**INVITATION TO BID
ADDENDUM NO. 2**

DESCRIPTION: Sisters Maintenance Station Relocation

ADDENDUM NO. 2
TO PLANS AND SPECIFICATIONS

OREGON DEPARTMENT OF TRANSPORTATION
SISTERS
MAINTENANCE STATION RELOCATION
Sisters, Oregon

FACILITY NO.		SHEET 3 OF 63
DATE	1/27/12	
FILE NUMBER	10001	DRAWING NO. C1.0
	SISTERS MAINTENANCE STATION RELOCATION

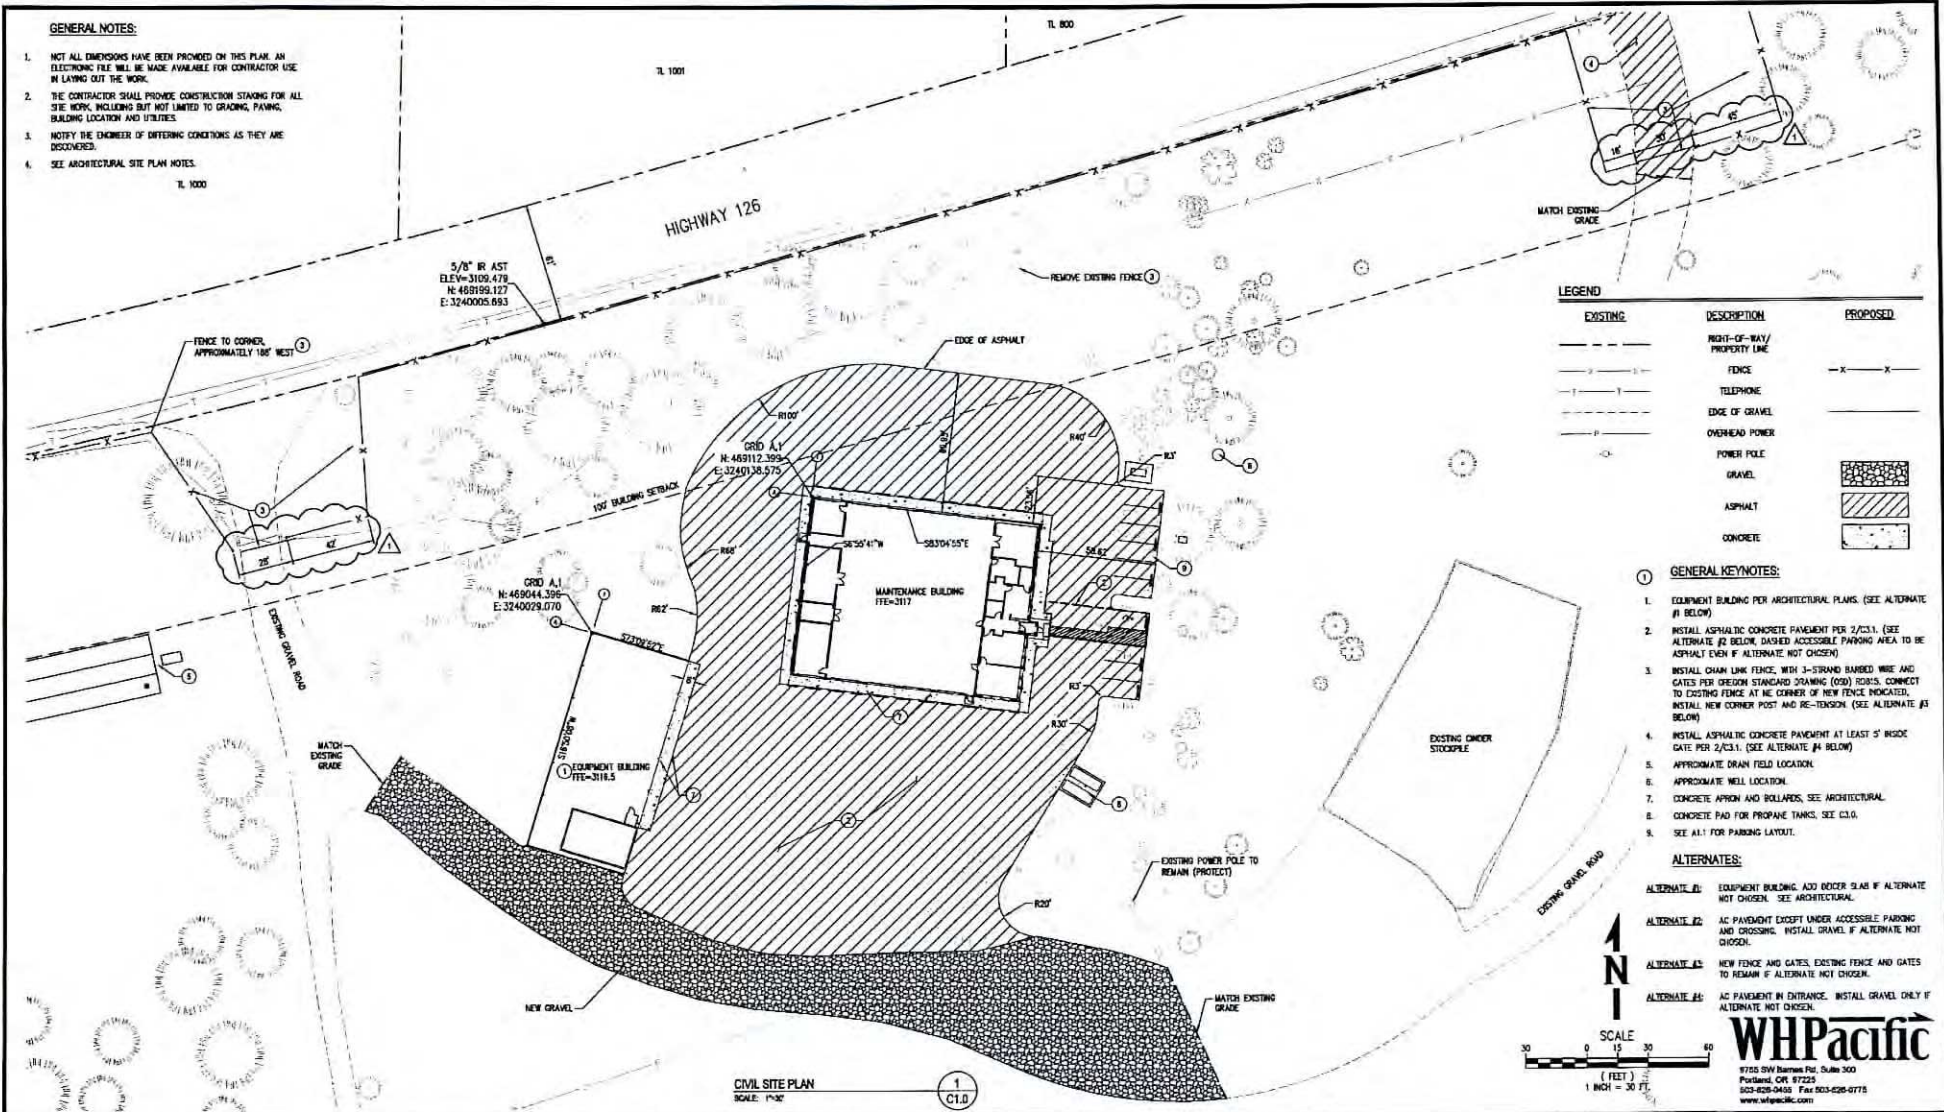
1. Sheet C1.0 Civil Site Plan:

- a. General Keynotes 3, Revise as follows: "3. Install chain link fence, with 3-strand barbed wire and gates per Oregon Standard Drawing (OSD) RD815. Cantilever Gates to be "Comunello" cantilever gates and equipment per the attached edited ODOT specifications. Two gates are to be installed:

West Gate – 28' opening, no operator

East Gate – 30' opening with operator

Contractor to notify Agency Project Manager if width of the access area will not accommodate the proposed equipment to coordinate fence adjustment."

SUBMERSIBLE WELL DETAIL
SCALE: N.T.S.

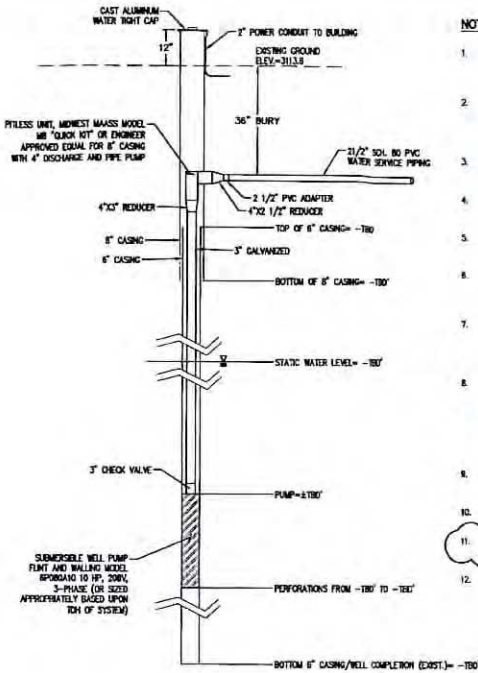
- c. Clarification on gpm: Pump remains as specified. Change note 11 on C3.1 to "Well shall be capable of providing 25 gpm...". See attached sheet. Note 11 has been changed to recognize the reservoir.

11. PUMP SHALL BE CAPABLE OF FRONTING 25 GPM TO BUILDING AND TO TANK FILL AT ELEVATION 3110.
12. THE CONTRACTOR OBTAIN PERMITS AND APPROVALS FOR THE WELL AND SHALL INSTALL, TEST, AND CONFIRM PUMPING EQUIPMENT.

TREE PLANTING AND
STAKING DETAILS

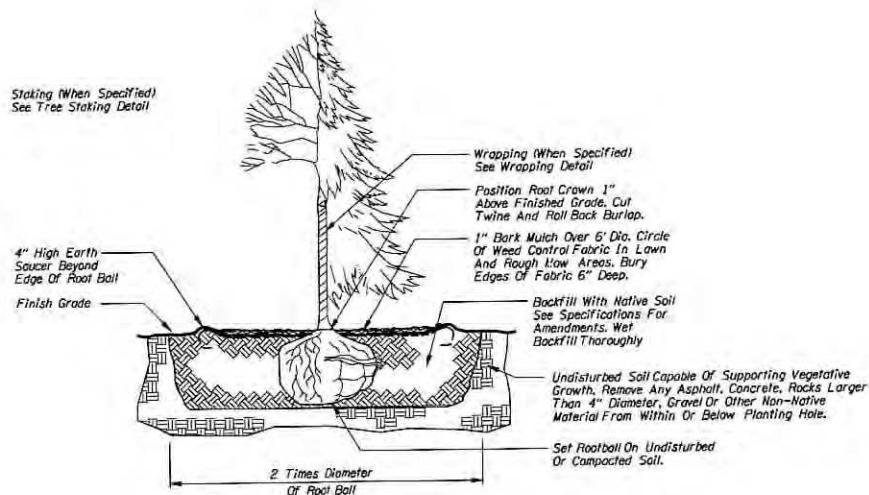
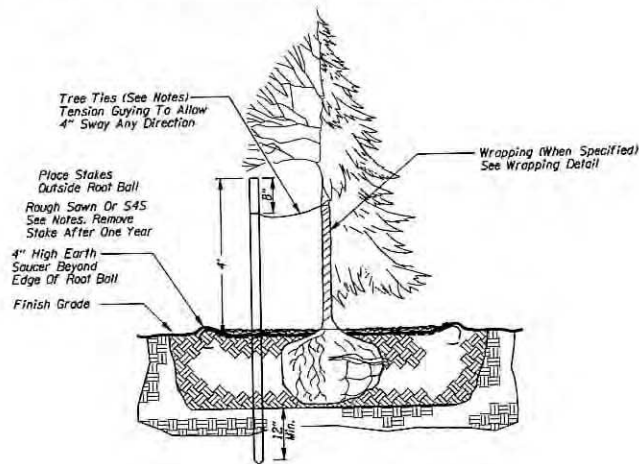
4. Sheet A1.0 Key Plan & Site Plan:
 - a. Change responsibility for the new landscape buffer ponderosa pines from ODOT to Contractor.
 - b. Provide and install 41 Conifer Trees, 6 - 8 feet height (*Pinus ponderosa*). Install per Tree Staking Detail (Det6100) and standard specifications. Locate trees as shown and obtain approval of location from ODOT Project Manager prior to planting. Maintain new trees in a healthy and vigorous condition for a one-year establishment period.
 - c. See attached Tree Planting and Staking Details drawing. Plant pit backfill to consist of 1/3 soil conditioner (conforming to 01040.15(b) and 2/3 soil mix. Soil mix to consist of ½ native sandy loam soil and ½ imported topsoil (conforming to 01040.14(b)). References are to ODOT standard specifications.

**FULL HEIGHT WALL BRACING
 GRID 6 - 2HR WALL**

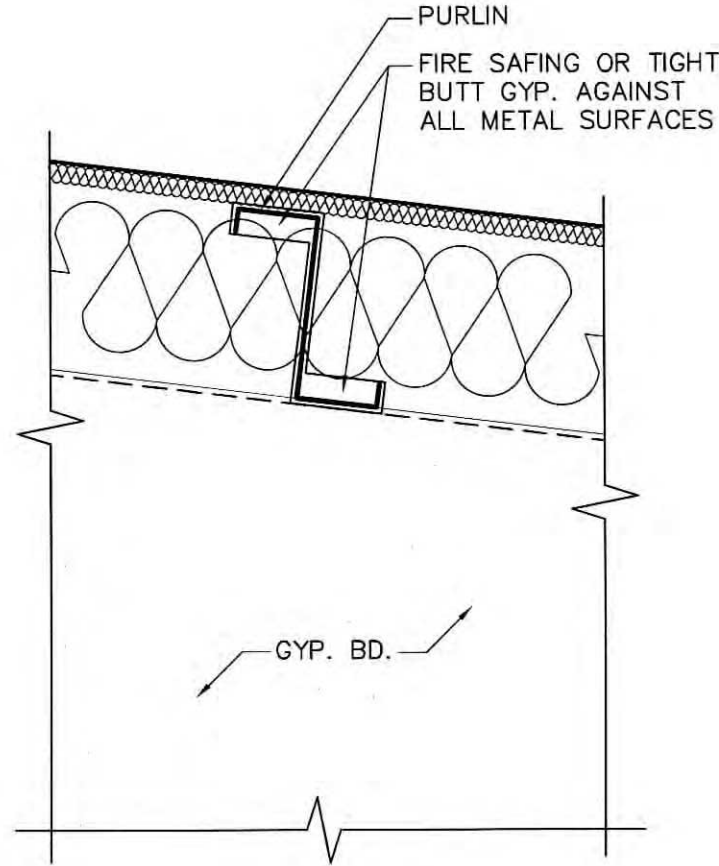
1. Change wall on grid line 6 from non-rated construction to 2-hour UL fire rated construction using Oregon Structural Specialty Code Table 720.1(2) 13-1.2, except studs are according to plans. Change door and frame assemblies for doors 108A, 109A, 115A, and 115B from non-rated to 1 ½ hour fire rated. Reduce relite in door 115A and 115B to maximum of 100 square inches, rectangular shape, approximately 4 inches wide and located on the latch side of the door. Adjust width of door frames and relite frames to fit wall in same manner as presently detailed. Office 103 wall, change relite assembly from non-rated to minimum 2-hour rated with Technical Glass Products FireLite (or approved substitution) in hollow metal frame. Meeting/Crew Rm 102, change relite assembly from non-rated to minimum 1 ½-hour rated with Technical Glass Products FireLite (or approved substitution). 2-hour glazing unit is 2 1/8" thick (verify with manufacturer). 1 ½-hour glazing is 3/16" thick (verify with manufacturer). Fabricate frames for 2-hour rated relite to accept the thickness of the glazing unit. Attached are revised door hardware groups, and wall details.

OSSC TABLE 720.1(2) NUMBER 13-1.2: USE STUDS AS INDICATED
 IN DRAWINGS AND SPECIFICATIONS, HOWEVER, MINIMUM
 FIRE-RESISTANCE ASSEMBLY REQUIREMENTS MUST BE MET.
 0.018" (NO. 25 CARBON SHEET STEEL GAGE) CHANNEL-SHAPED
 STUDS 25" ON CENTER WITH TWO FULL-LENGTH LAYERS OF 1/2"
 TYPE X GYPSUM WALLBOARD APPLIED VERTICALLY EACH SIDE.
 FIRST LAYER ATTACHED WITH 1"-LONG, NO. 6 DRYWALL SCREWS,
 8" ON CENTER AROUND THE PERIMETER AND 12" ON CENTER ON
 THE INTERMEDIATE STUD. SECOND LAYER APPLIED WITH VERTICAL
 JOINTS OFFSET ONE STUD SPACE FROM FIRST LAYER USING
 1-5/8" LONG, NO. 6 DRYWALL SCREWS SPACED 9" ON CENTER
 ALONG VERTICAL JOINTS, 12" ON CENTER AT INTERMEDIATE STUDS
 AND 24" ON CENTER ALONG TOP AND BOTTOM RUNNERS.

1 BOLLARD W/ CARD READER
 A3 SCALE: 3/4" = 1'-0"

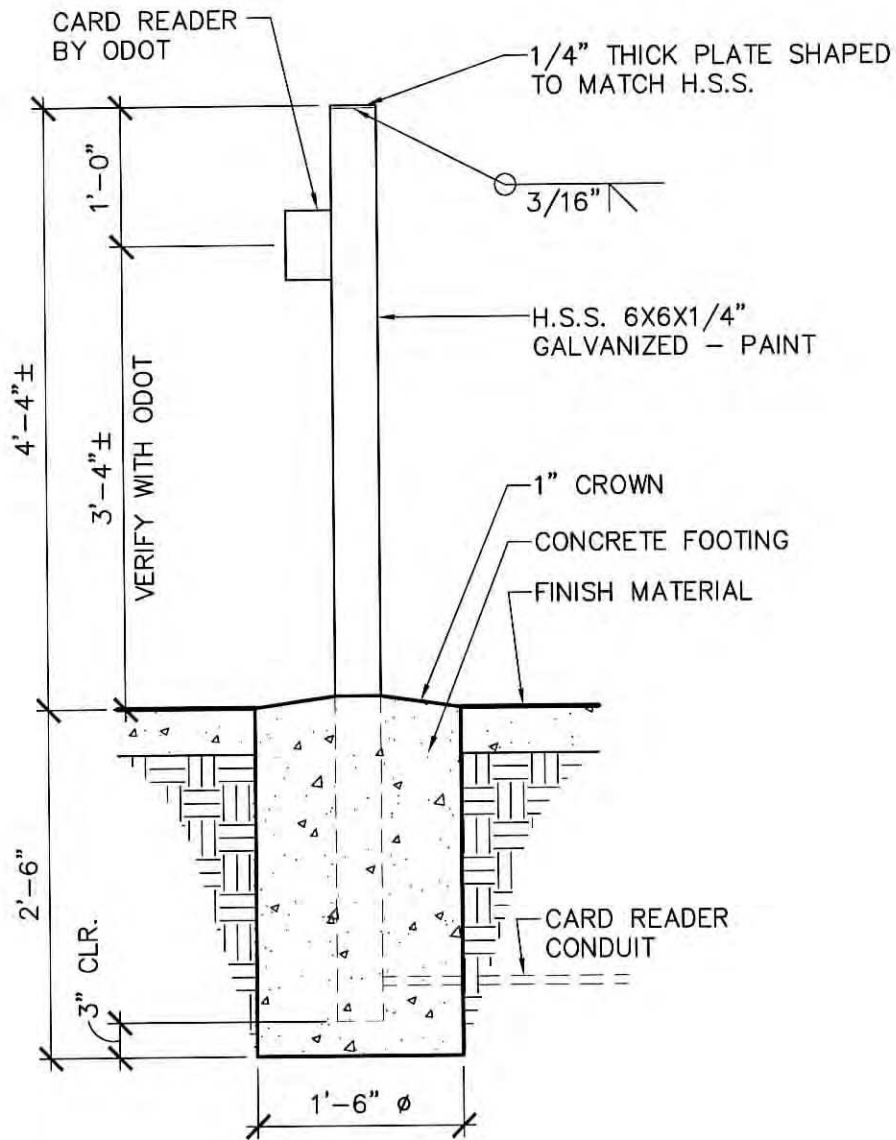
2. East gate card reader bollard detail is attached.
3. Metal studs substitution: 3 5/8 inch studs may be used instead of 3 1/2 inch studs. Contractor shall make all necessary adjustments necessary to accommodate the 3 5/8 inch studs.
